ADDENDUM NO. 2

Issue Date:	January 17, 2024
Project Name:	Sandridge Golf Club New Clubhouse
ITB Number:	2024029
ITB Opening Date:	**February 1, 2024**

This addendum is being released to provide answers to questions received to date, modify the bid documents, provide additional background documents, and provide minutes to the pre-bid meeting.

A 805

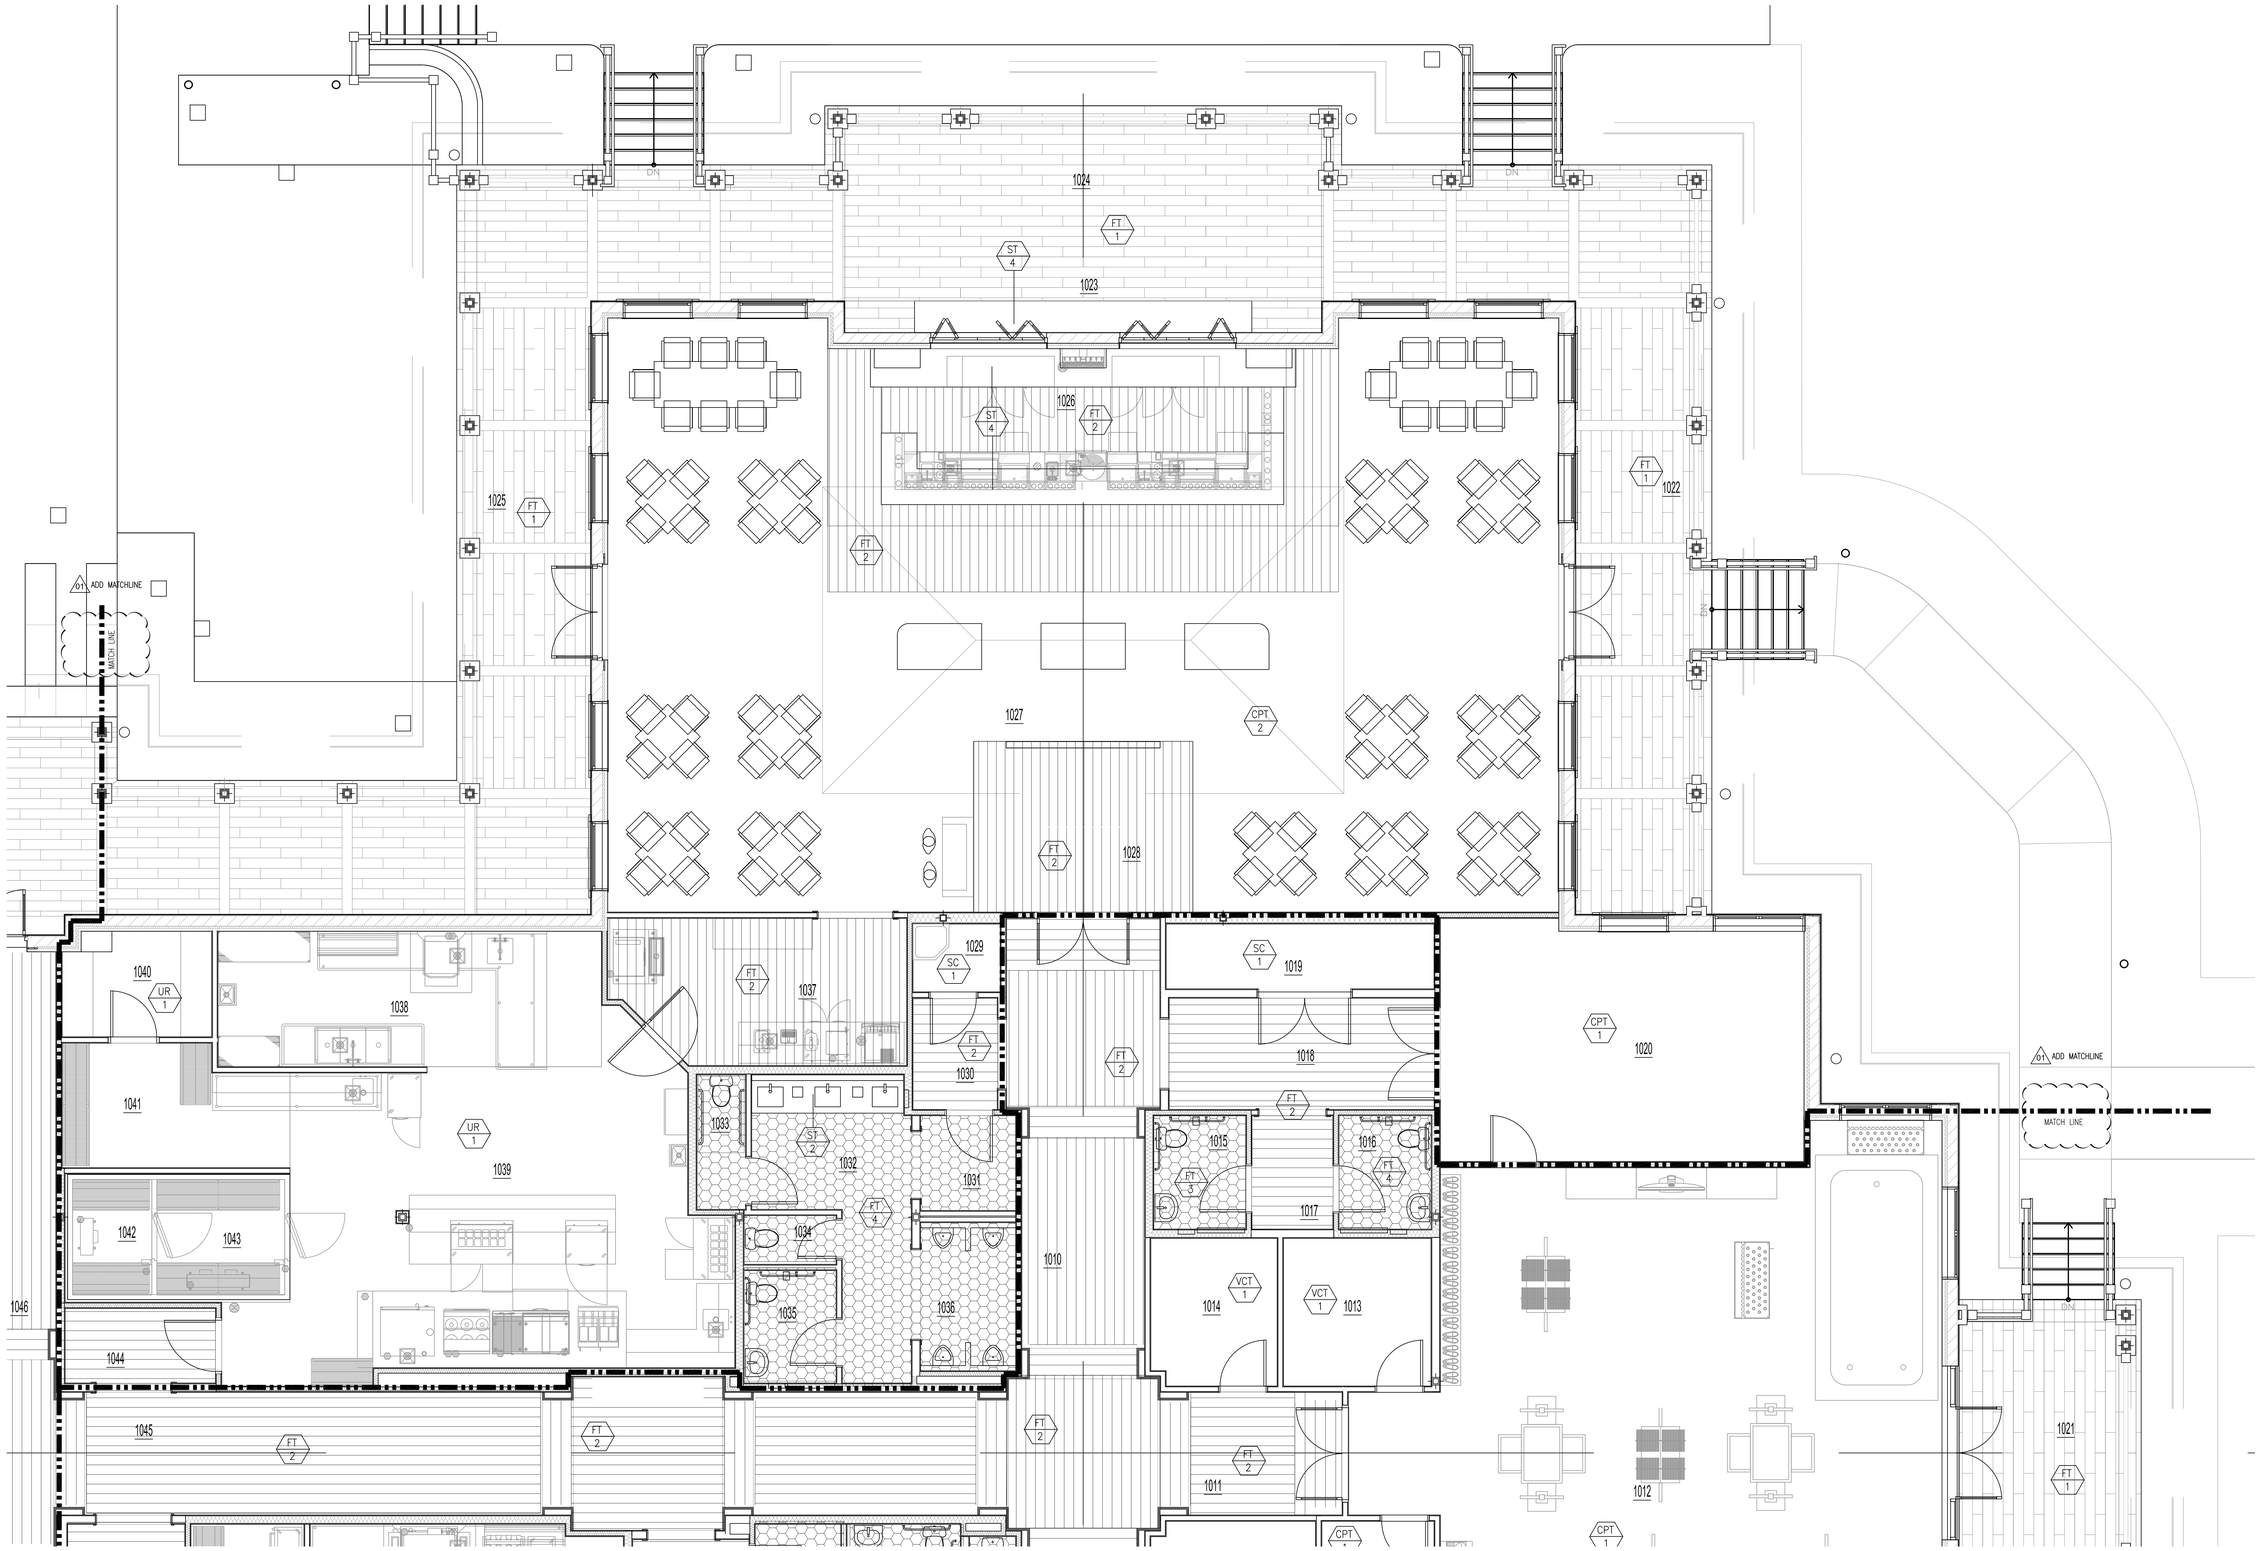
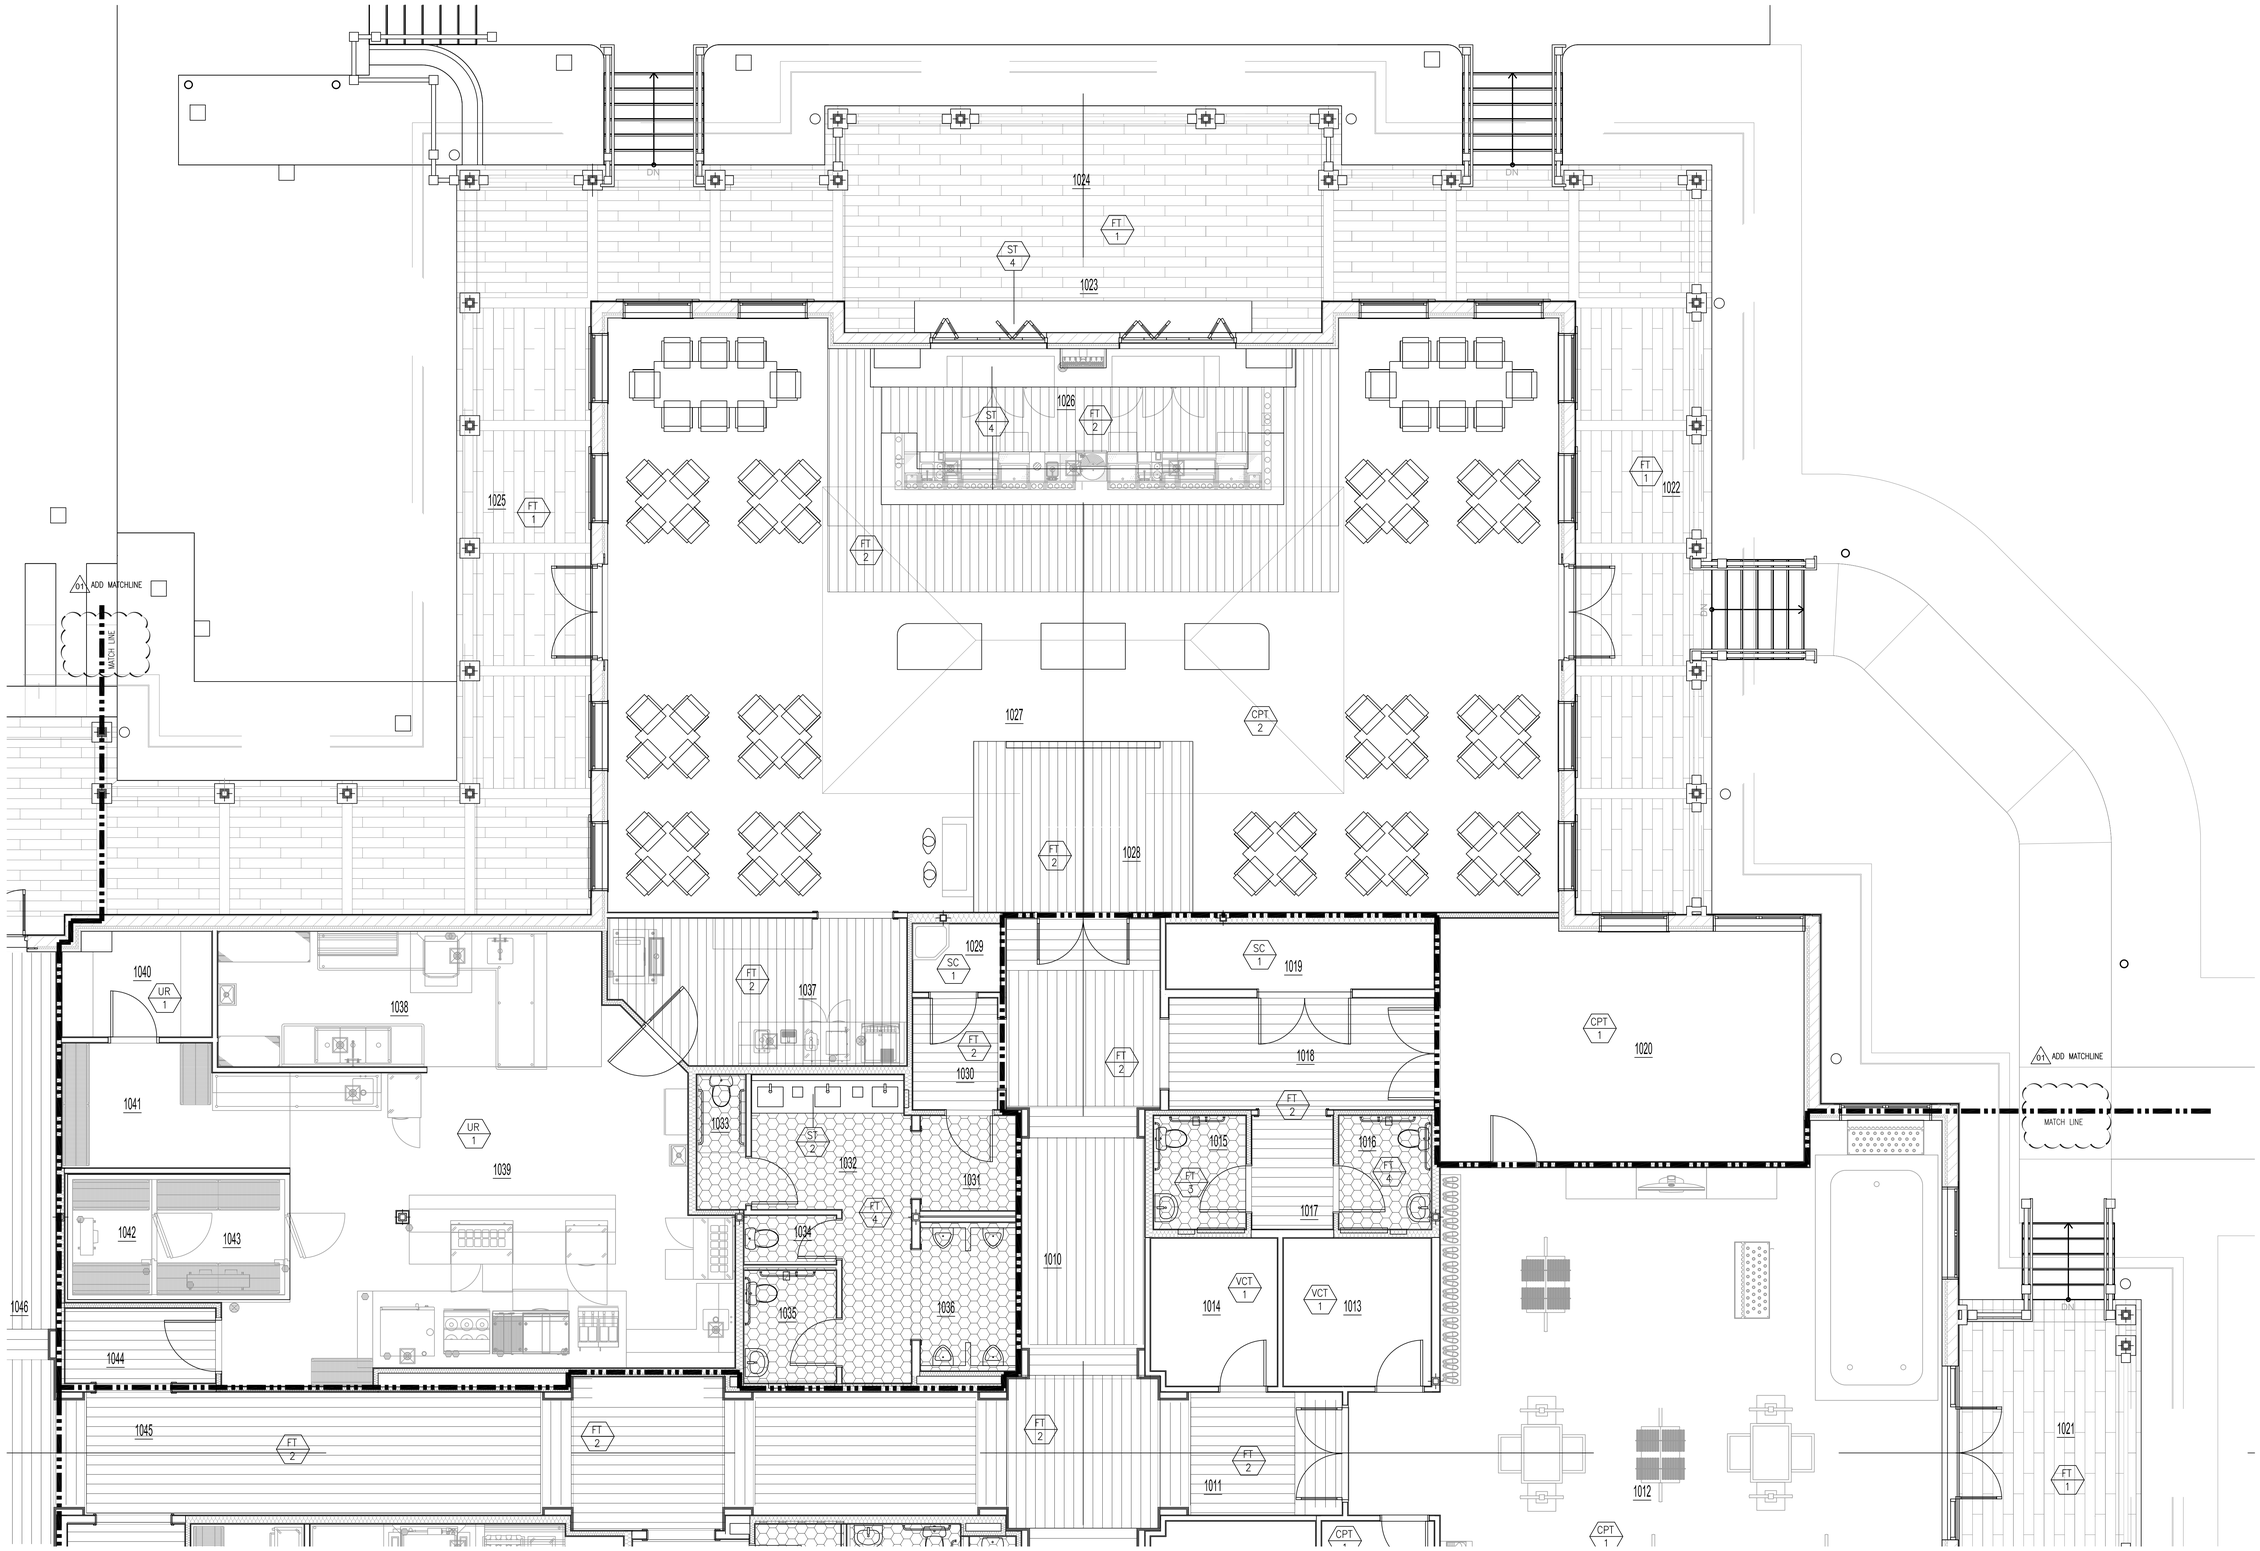
15. PLEASE CONFIRM THE ROLL DOWN MOTORIZED SCREENS ARE BY OWNER.
Roll down motorized screens are contractor furnished/contractor installed. See revised sheets A411, A605, A805, I216 and I217 for additional information.
